Re: **Marbach Village Subdivision** **MDP # 045-06**

The City Staff Development Review Committee has reviewed Marbach Village Subdivision Master Development Plan **MDP # 045-06**. Please find enclosed a signed copy for your files. Your plan was approved for acceptance, however please note the following:

MASTER DEVELOPMENT PLAN

SHEET
C4

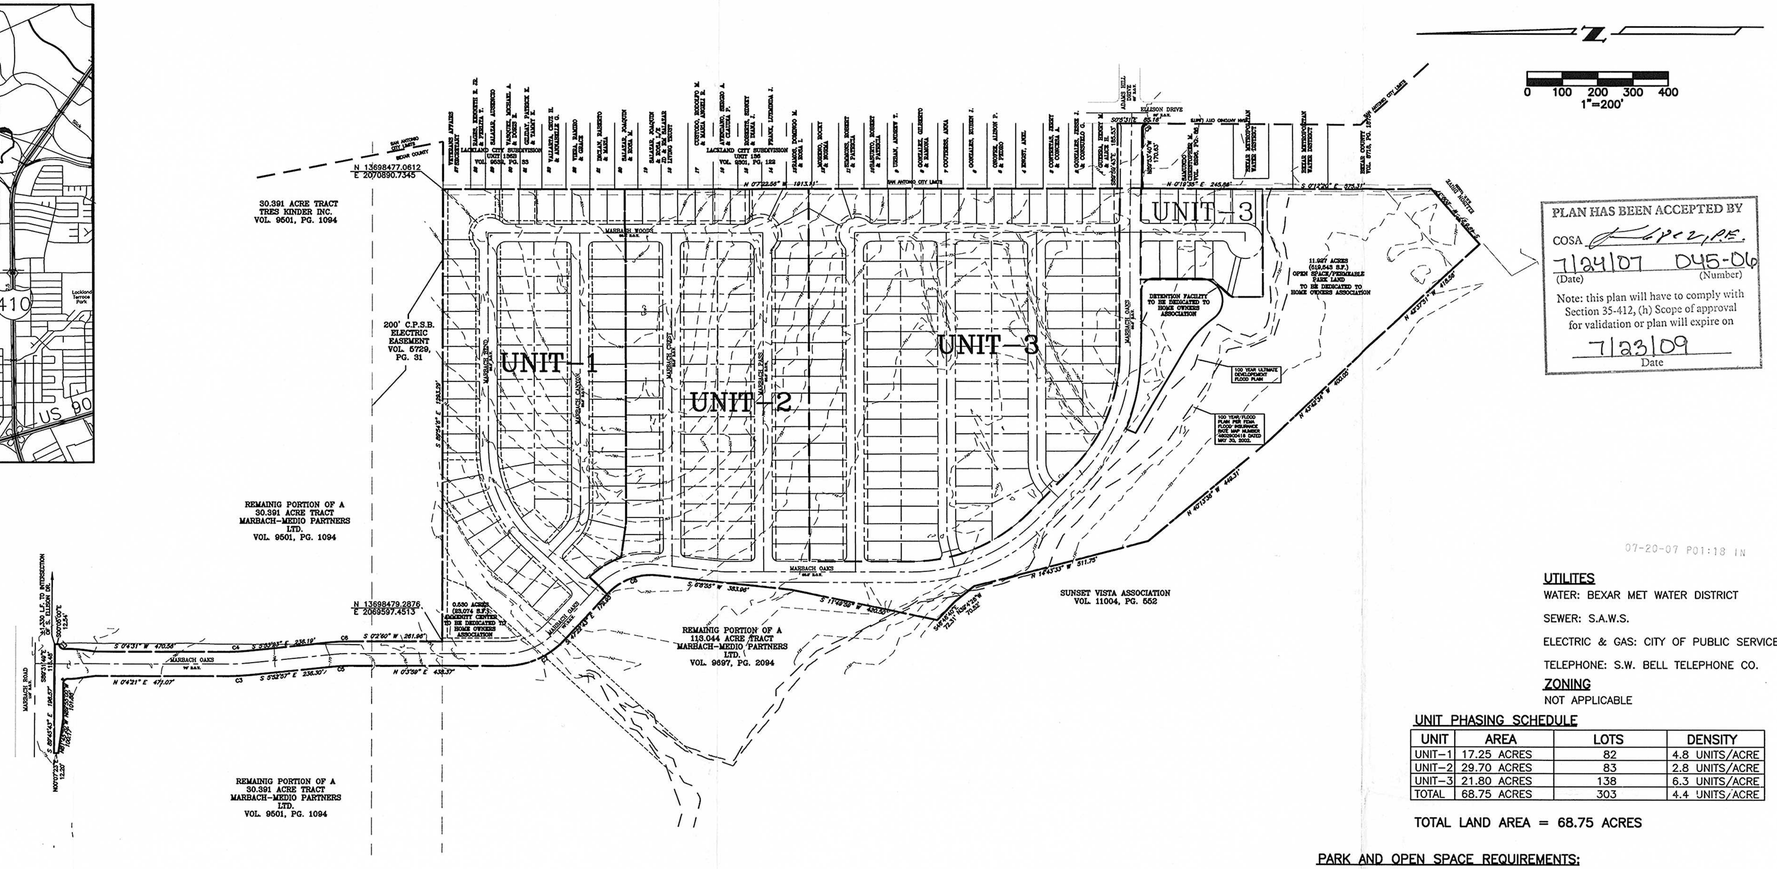
In consideration of public safety and convenience, excessive grades by reason of topography should be avoided in street layouts and arrangements. Any access and R.O.W. issues along state facilities will need to be resolved with the **Texas Department of Transportation (TXDOT)**. For information about these requirements you can contact TXDOT at 615-5814.

- A right / deceleration lane will be required at Marbach Rd. and Marbach Oaks.

- Streetscape standards per UDC Section 35-512 - The new ROW on Marbach Oaks will require streetscaping.

Parks and Recreation Department: Marbach Village is a proposed subdivision with 303 single-family residential units. UDC Section 35-503, Table 503-1 states that single-family development is required to provide 1 acre of park/open space per every 70 dwelling units. The requirement for this development is 4.3 acres. This subdivision provides 8.6 acres inside the 100-year flood plain for a credit of 2.15 acres of open space dedication, plus 3.3 acres outside the floodplain. Also, 0.9 acres credit is awarded for two pools totaling 1,040 square feet of water surface area. The total amount of parkland dedication for this project is 6.1 acres.

- The parkland provided shall be shown as "Park" or "Open Space" on a plat; UDC sections 35-503(e) *Designation of Parkland.*

- Parkland dedication shall be platted by the second phase of residential development; UDC section 35-503(f) *Development Phasing.*
